Our Ref: DB2015-0020

SYSTEM DESIGN ENGINEERING ACCEPTANCE OF THE UNIT 1 ILRT (OUTAGE 121) STRUCTURAL INTEGRITY TESTS RESULTS

Project No.	Your Ref.	Our Ref.	Date
JN 411		JN411-NSE-ESK-L-6081 Rev 0	29 June 2015

Assessment of EdF Report on Outage 121 ILRT

Figure 1: Temperature Evolution at 4 Bar

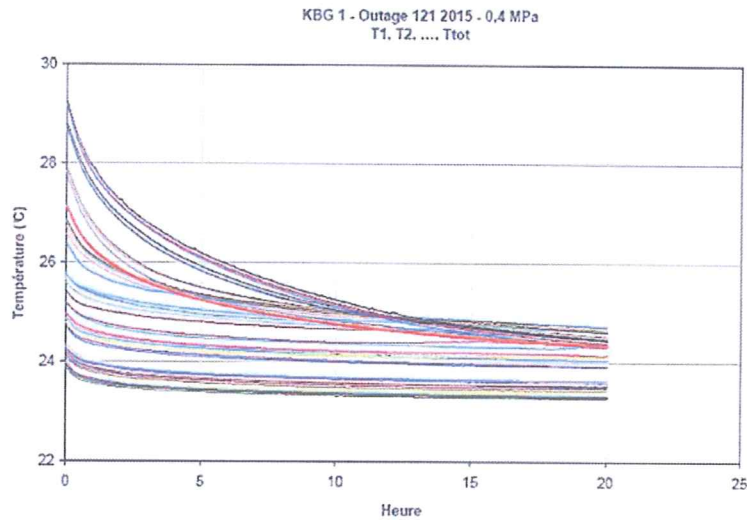
The hold period at the 4 bar stage was extended by 4 hours as it was suspected that the temperatures had not stabilised (Refer Figure 1). Acceptable results were then obtained.

Figure 2: Comparison of pendulum data for Unit 1

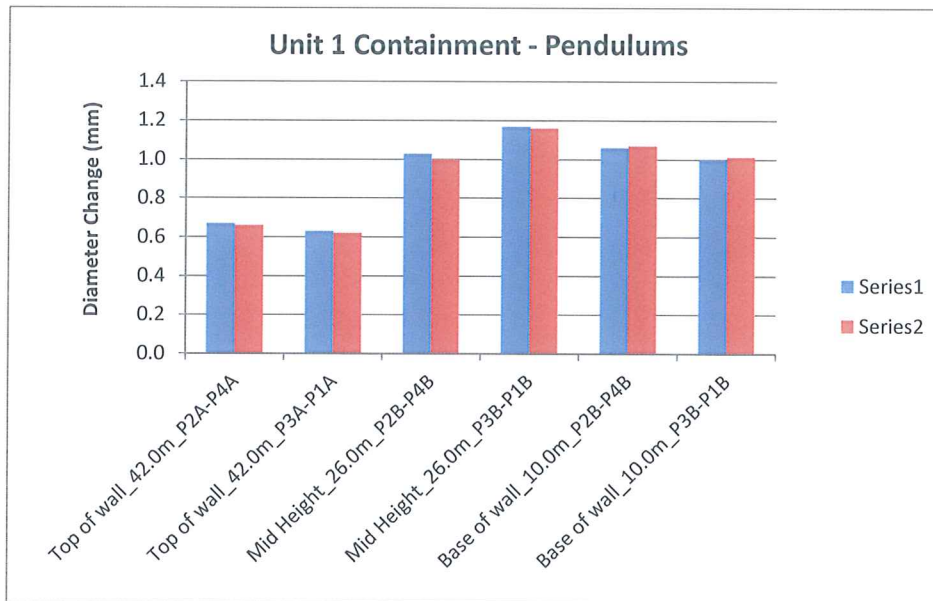
- A maximum increase in diameter of 10.8 mm was measured from the pendulums. In contrast, the extensometers indicated an increase of 8.6 mm.
- Based on the graphs on Page 9 of the EdF presentation the horizontal increase in diameter appears to be close to linear. However, on inspection of the SITES results some variation of the linear trend is observed. The largest hysteresis of approximately 1.5 mm on a single pendulum occurs on pendulum 241 26 R P1B EAU112.
- The largest hysteresis of approximately 2 mm on diameter occurs on P3B – P1B and P3C-P1C.
- The difference in the pendulum data to the 2005 ILRT is very small (Refer Figure 2 & Table 2).

Figure 3: Comparison of invar wire data for Unit 1

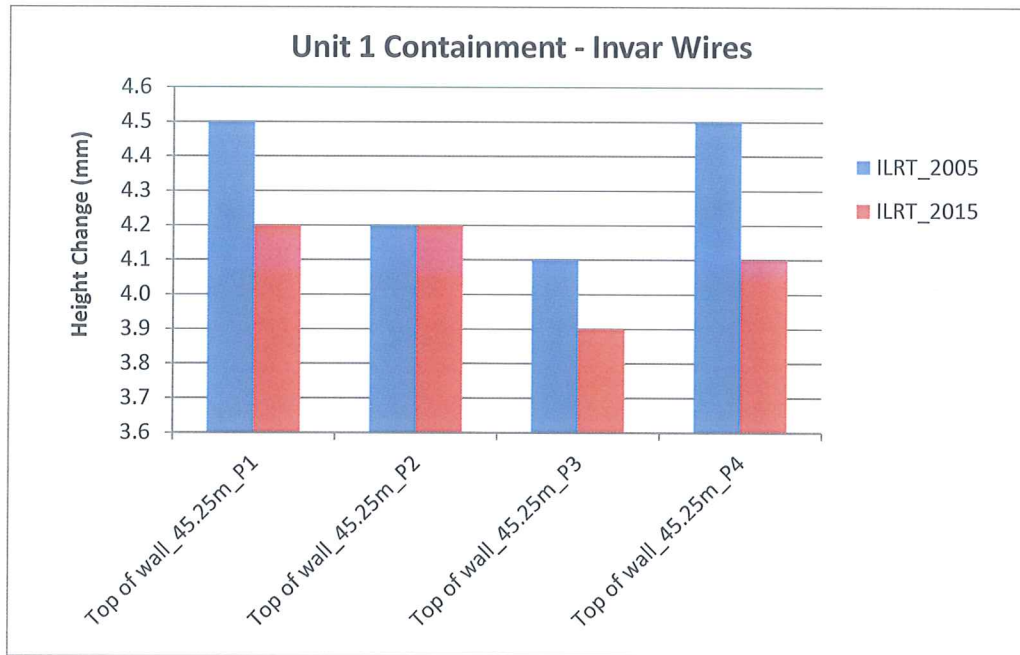
- An average increase in height of 4.1 mm was measured by the invar wires. The extensometers indicated a 3.6 mm vertical deformation.
- Based on the graphs on Page 10 of the EdF presentation, the vertical behaviour under pressurisation appears to be linear although there is an aberration at the 1 bar hold point which would require further investigation. The depressurisation is linear on 2 wires but shows some non-linearity on the other two. The reason for this non-linearity should be investigated.
- Temperature appears to have an influence on the stiffness of the structure especially during depressurisation. Temperature was recorded as 13.2°C (0 to 1 bar stage) and 17.1°C (1 to 4 bar stage).
- The largest hysteresis of approximately 0.5 mm on height occurs on P1.
- The difference in the invar wire data to the 2005 ILRT is very small (Refer Table 3 & Figure 3).

Figure 4: Comparison of dynamometer data for Unit 1

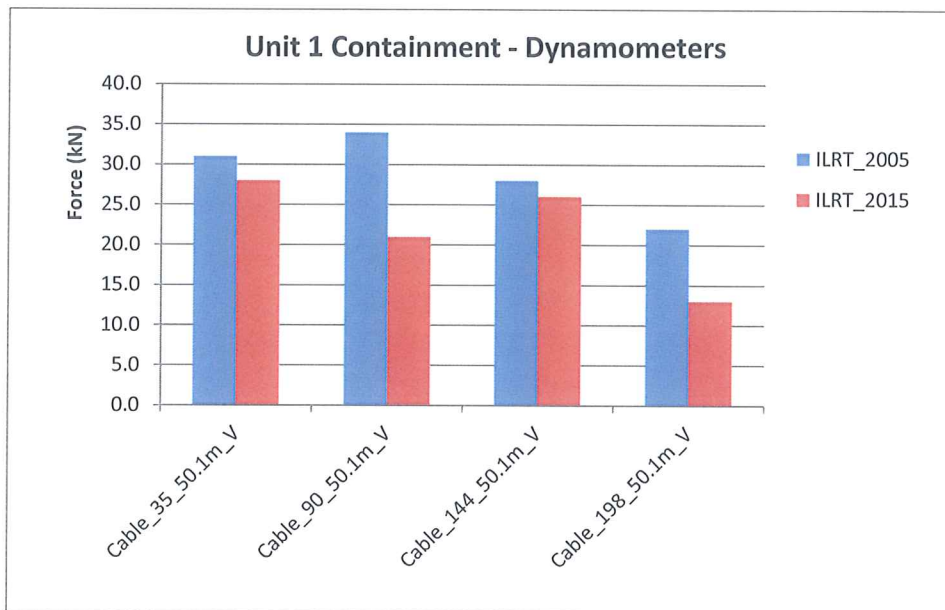
The comparison of dynamometer data with the 2005 ILRT shows rather large differences on cables 90 & 198 (Table 5 and Figure 4). Only 62% and 59% of the force recorded in 2005 for cables 90 & 198 respectively were reached during this ILRT. Measurements on cables 35 and 144 were within 90% of the forces measured in 2005. The average force in the ungrouted tendons was measured to be 22 kN as opposed to 28.75 kN measured in 2005.

It is recommended that reasons for the differences in dynamometer readings to those taken in 2005 as well as the relatively low forces in cables 90 and 198 during this ILRT be obtained given that the deformation measurements are close to those measured in 2005.

However, it is recommended that reasons for the differences in dynamometer readings to those taken in 2005 as well as the relatively low forces in cables 90 and 198 during this ILRT be obtained given that the deformation measurements are close to those measured in 2005.

Dynamometer measurements should be taken at the end of July 2015 to check whether the residual force has reduced.

Figure 5: Comparison of extensometers in the Unit 1 Dome

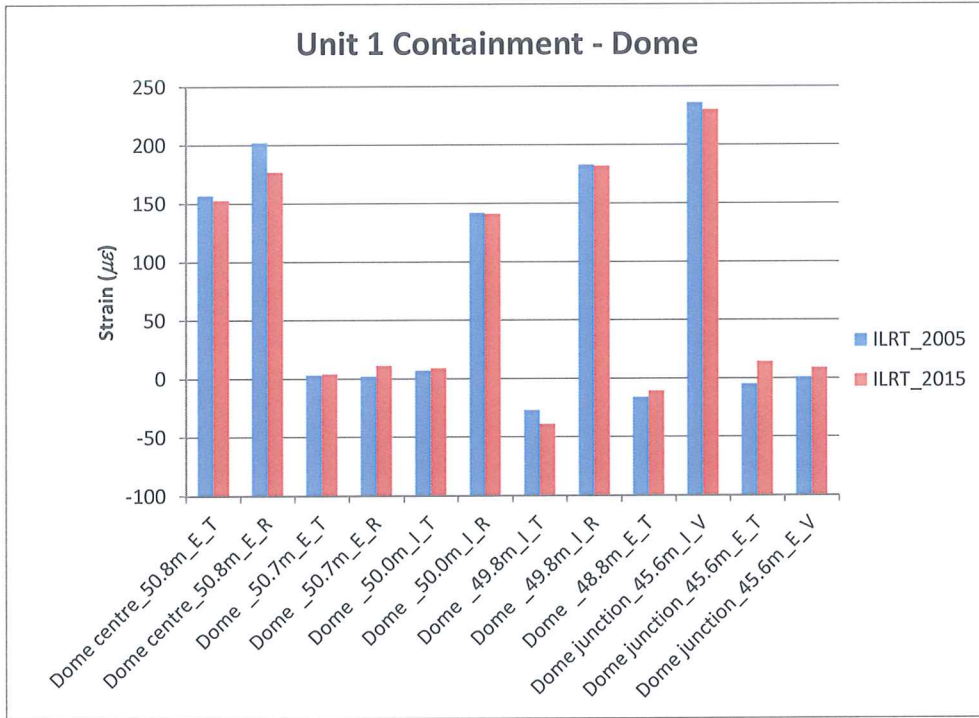
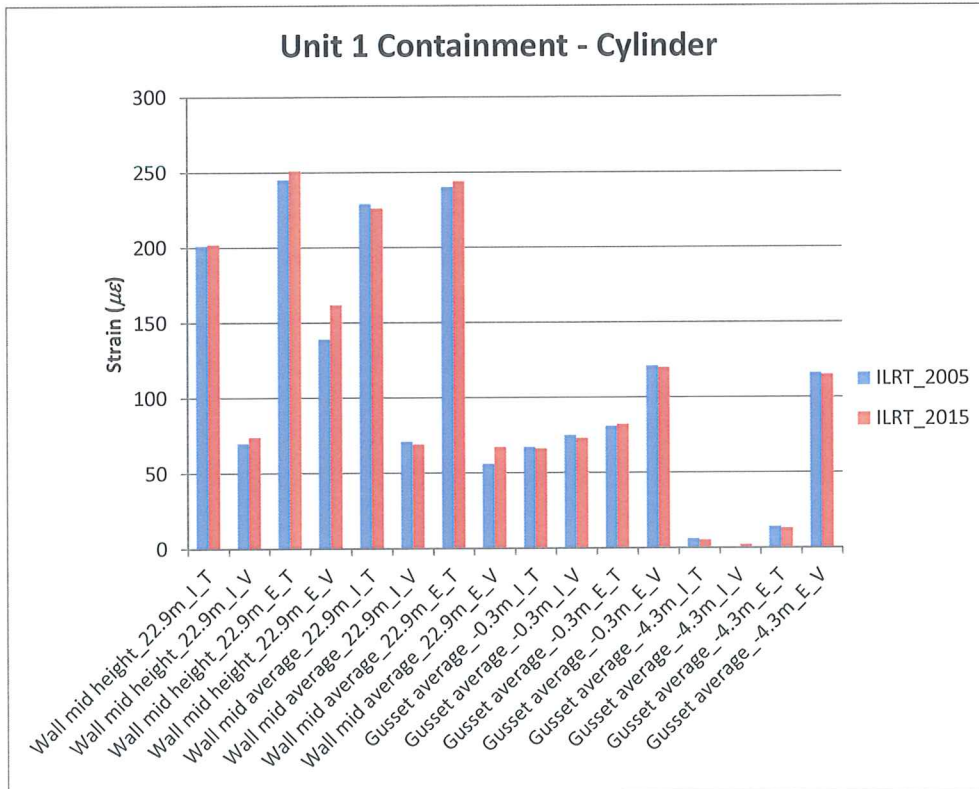
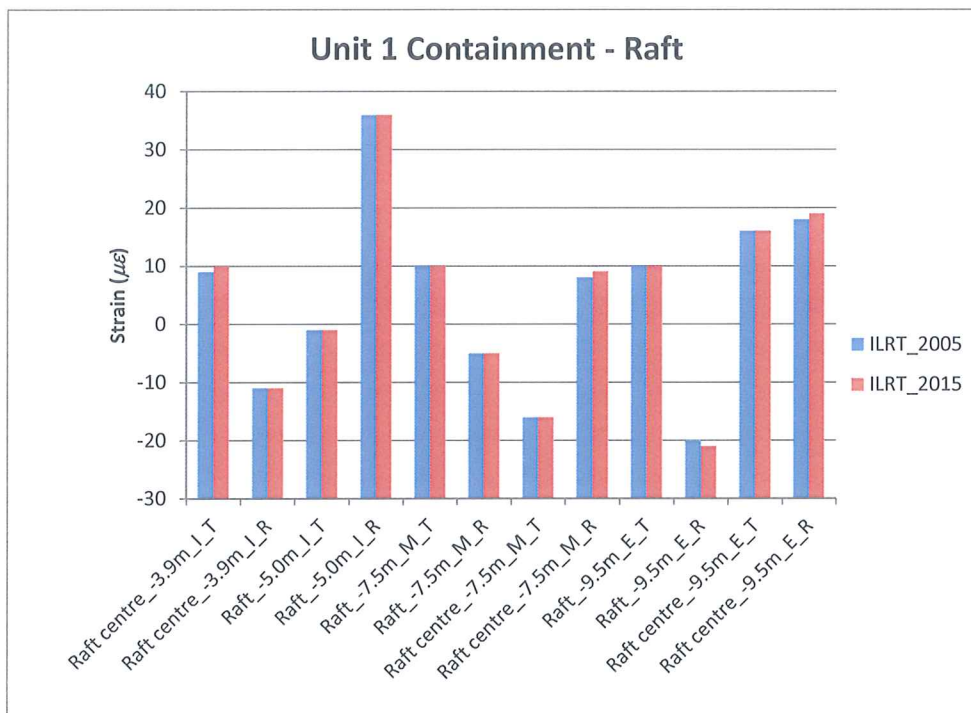
- Essentially liner behaviour is noted but the dome does indicate a degree of non-linear behaviour.
- Detailed results are presented in the SITES report. Location of non-linear behaviour should be checked against the results of the finite element model.

A comparison is made between extensometer readings during the 2005 and 2015 ILRT's in Figure 5 to Figure 7. It is also clear from the plots and the data listed in Table 7 that the difference in strain measurements from 2005 to 2015 is very small.

The location of extensometers demonstrating non-linear behaviour should be checked against the results of the finite element model.
